Access Compliance Report

Public Rights-of-Way

Intersection ID: 18012	Main Street: RAMA_RD	Cross Street: CHARING_PL	Location: NE
ADA ID: 99022F088D82	Ramp Type: PerpDiag	Initial Pass/Fail: Fail	Overall Compliance: No
		Severity Score: 12.5

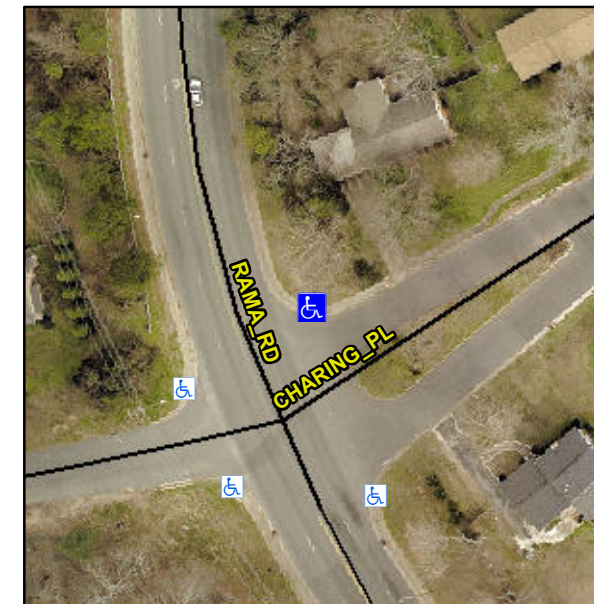
Not Found, R304.2.2

Compliance	Description	Data	Compliance	Description	Data
N/A	Ramp Length (in)	60.0	No	Ramp Slope (%)	9.9
Yes	Ramp Width (in)	48.0	Yes	Ramp XSlope (%)	1.4
N/A	Flare Type LT	N/A	N/A	Flare Type RT	N/A
N/A	Flare Slope LT (%)	N/A	N/A	Flare Slope RT (%)	N/A
N/A	Flare Traversable LT?	N/A	N/A	Flare Traversable RT?	N/A
N/A	Landing Length (in)	N/A	N/A	DWS Provided?	N/A
N/A	Landing Width (in)	N/A	N/A	DWS Contrast?	N/A
N/A	Landing Slope (%)	N/A	N/A	DWS Length (in)	N/A
N/A	Landing X Slope (%)	N/A	N/A	DWS Full Width?	N/A
N/A	Landing Curb? (Y/N)	N/A	N/A	DWS Offset (in)	N/A
N/A	Shared Landing?	N/A			
N/A	Gutter Ponding?	N/A	N/A	Gutter Slope (%)	N/A
N/A	Gutter Lip Ht (in)	N/A	N/A	Gutter X Slope (%)	N/A
N/A	Painted X Walk1?	No	N/A	Painted X Walk2?	No
	X Walk 1 Direction	To SW		X Walk 2 Direction	To S
N/A	X Walk 1 Width (in)	N/A	N/A	X Walk 2 Width (in)	N/A
	X Walk 1 Slope (%)	6.8		X Walk 2 Slope (%)	1.9
	X Walk 1 X Slope (%)	1.8		X Walk 2 X Slope (%)	6.8

Remove & Replace Curb Ramp With Two New Directional Ramps or Equivalent.
